Re: Powder Mills Apartments – Special Use Permit Supplemental Information

On behalf of RYCO Management, Fisher Associates is pleased to submit this supplemental information regarding the application for a Special Use Permit for the proposed residential development located at 1151 Pittsford-Victor Road.

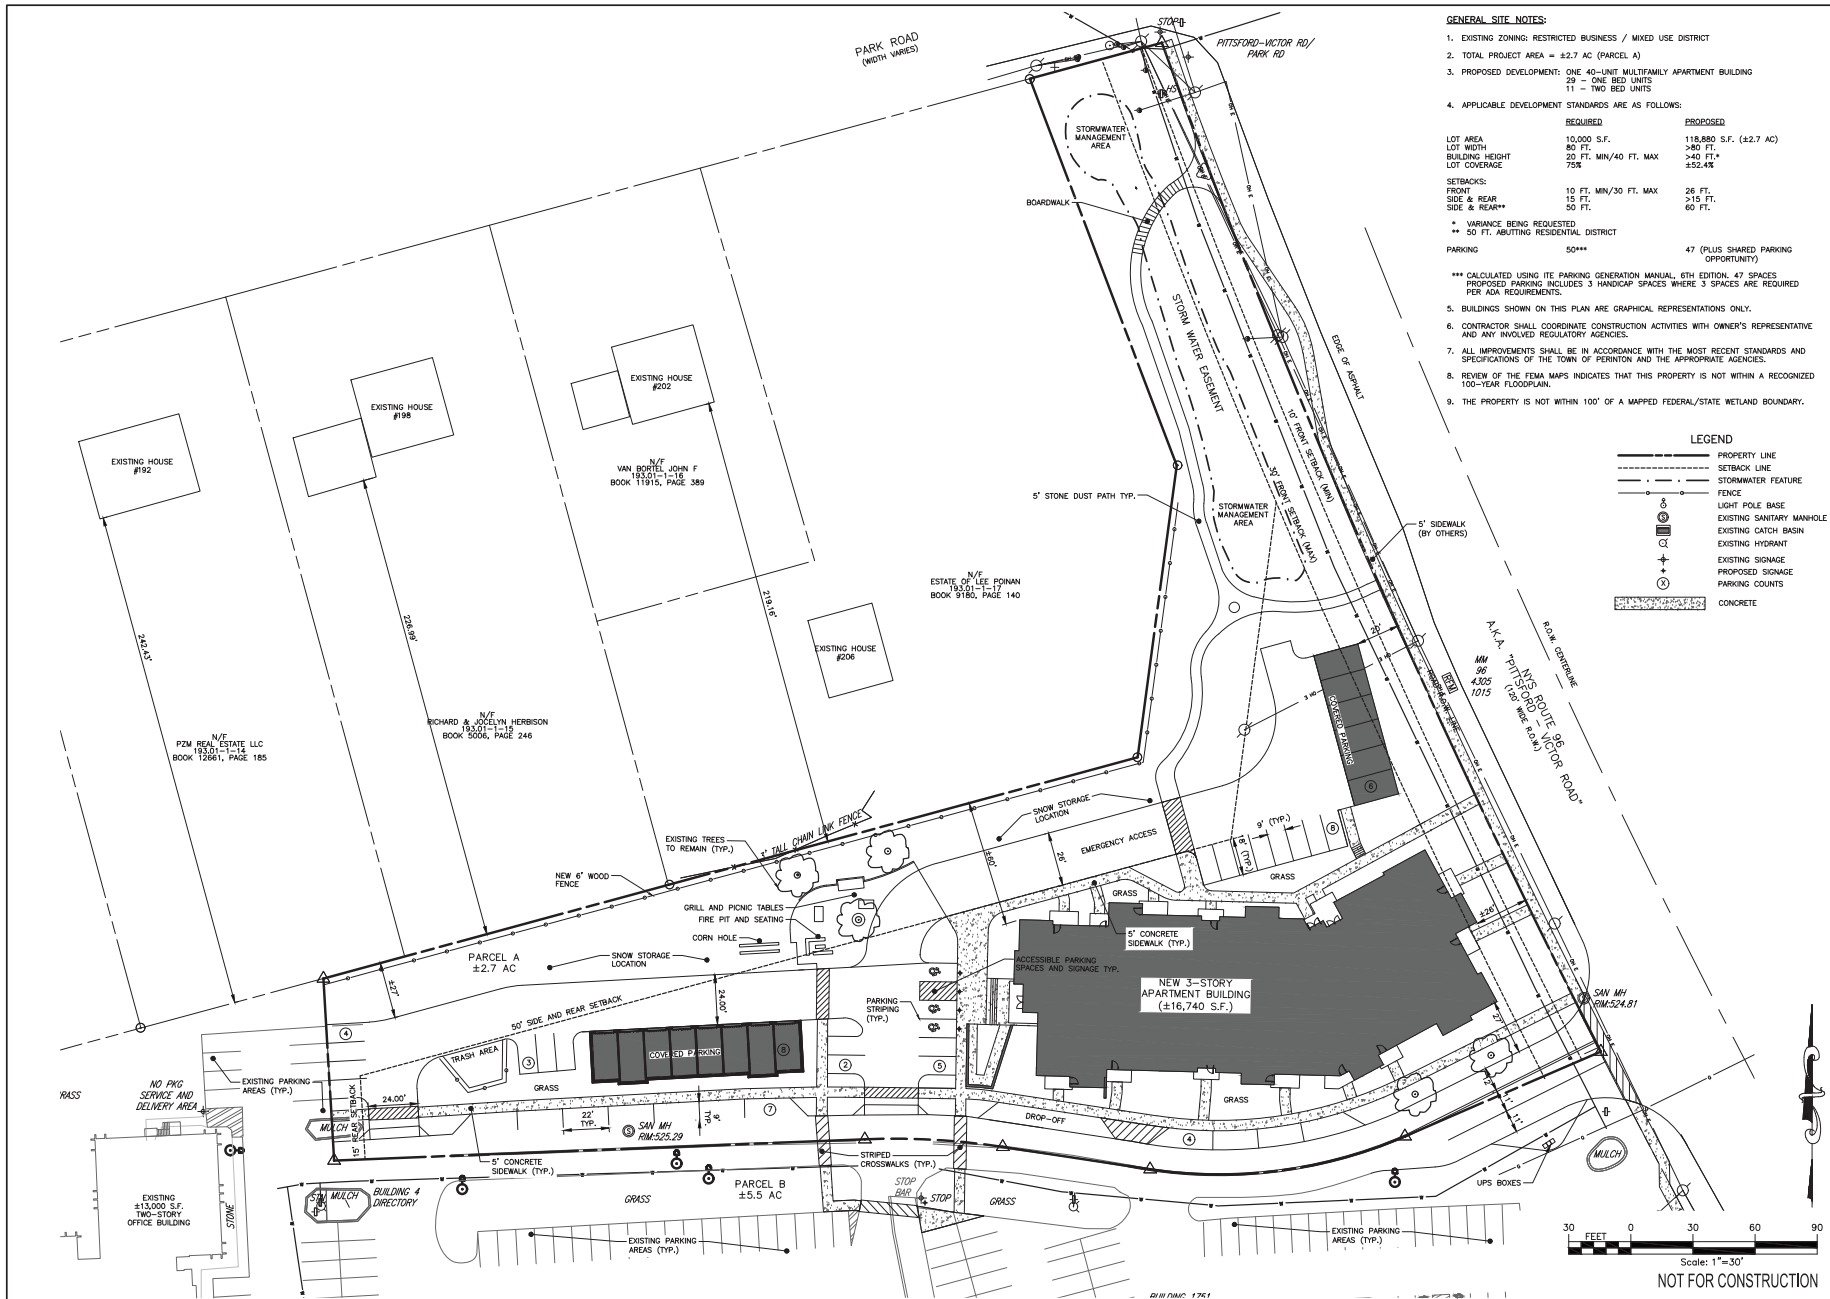
3. Buffer Area: Several modifications have been made to the Site Plan in response to minimizing the impact of the project on adjacent neighbors and respecting the 50' setback/buffer. The proposed redesign meets the Town Code's buffering purpose to "to separate or screen one zoning district or use from another zoning district". It should be noted that the Town's Comprehensive Plan recommends that both the residentially zoned area between the site and Park Road, and the project site itself, both be considered within the same mixed-use character area.

- 9 Proposed parking spaces were removed from the 50' Buffer Area.
 - 13 Existing parking spaces that are currently within 50' Buffer Area were also removed.

- 3 Existing parking spaces remain at the western edge of the site, adjoining the existing parking on the adjacent property.
 - Approximately 70% of the proposed emergency access and driveway on the north side of the buildings is built on existing paved parking areas. Only a minimal portion of the proposed driveway will be built over existing lawn.

- The eastern garage building was moved away from the Buffer Area so that the garage's associated driveway can be out of the Buffer Area - and to increase the size and shape of the buffer/open space.

- The fence along property line was realigned behind the property at 198 Park Road in order to keep it higher on the slope and create a taller buffer.

- The amenity area surrounding the large, retained Locust Tree was enlarged and better defined.
4. Pocket Parks & Amenity Areas: The current Site Plan improves the location, connectivity and size of open spaces and amenities. Four basic amenity spaces are created.

7. Snow Removal: Snow storage areas have been identified on the Site Plan. The Landscape Plan will be designed to accommodate snow placement in these areas.

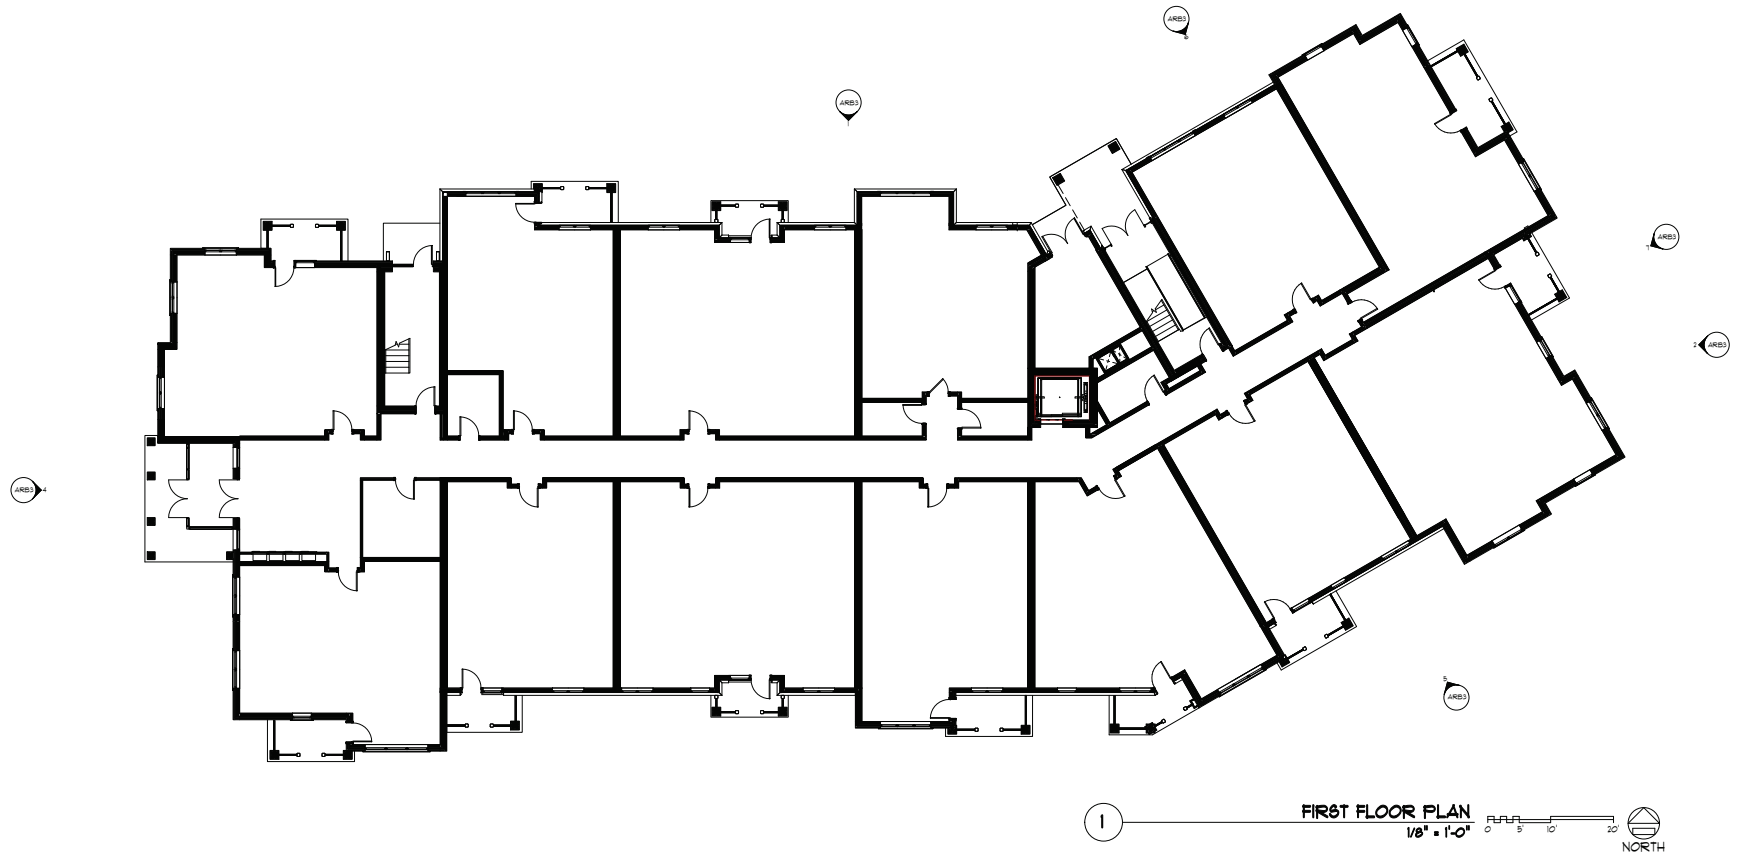
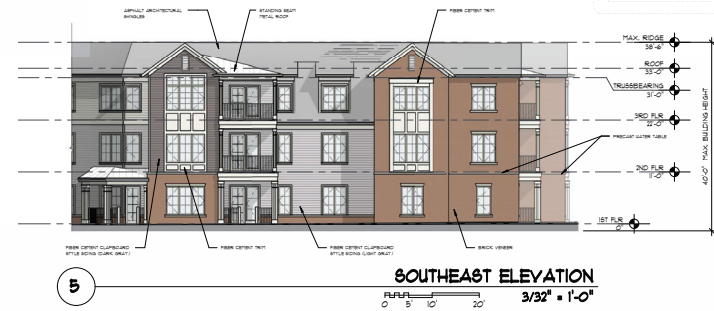
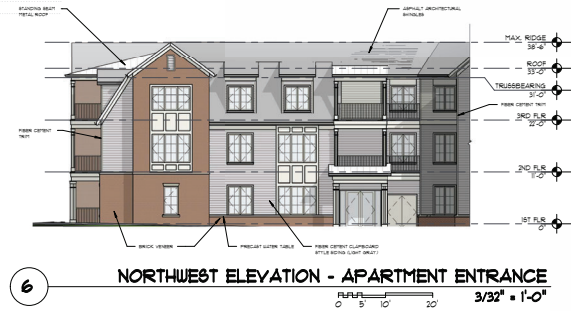
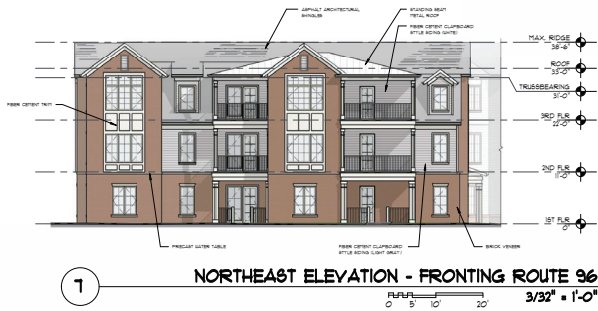
2. **Architectural Design & Massing:** At key visible locations, including the project entry at Pittsford-Victor Road and at the building entry at the west end of the building, gambrel roofs were introduced to lower the eave height to the top of the second story and to reduce the scale of the vertical wall height. Dormers were added to maintain natural light into these apartments, and to break up the roof face. At key southeast and southwest corners of the building the brick veneer was extended to the full height of the building, vertical variation in the façade was emphasized.

The main building entrance was simplified with a "lighter" sloped canopy over the vestibule. A section of gambrel roof was included above to the doors to reduce the scale.

Building materials have been called out to include brick veneer, fiber cement clapboard, and asphalt architectural shingles.

The western garage buildings were combined from two, 6-bay buildings to one, 8-bay building. A fenced-in area for trash pick-up was added.
